UNITED STATES DEPARTMENT OF THE INTERIOR BUREAU OF LAND MANAGEMENT

PLUG AND ABANDONMENT PROCEDURE

AXI Apache J #28

CONDITIONS OF APPROVAL

AXI Apache J #28 Proposed P&A

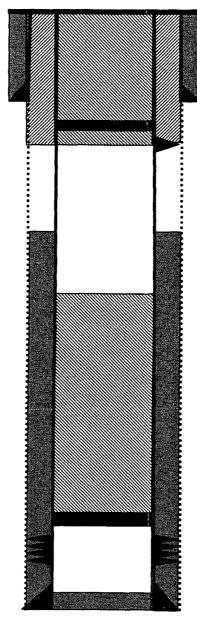
- 1. Plugging operations authorized are subject to the attached "General Requirements for Permanent Abandonment of Wells on Federal and Indian Lease."
- 2. Farmington Office is to be notified at least 24 hours before the plugging operations commence (505) 599-8907.
- 3. The following modifications to your plugging program are to be made:
- a) Bring the top of the Pictured Cliffs/Fruitland/Kirtland/Ojo Alamo plug to 2058'
- b) Place the Nacimiento plug to 785' to surface inside and outside the 4 1/2" casing.

- b) Place the Nacimiento plug to 785' to 685' inside and outside the 4 ½" casing.
- c) Place the surface plug to 559' to surface inside and outside the 4 ½" casing

You are also required to place cement excesses per 4.2 and 4.4 of the attached General Requirements.
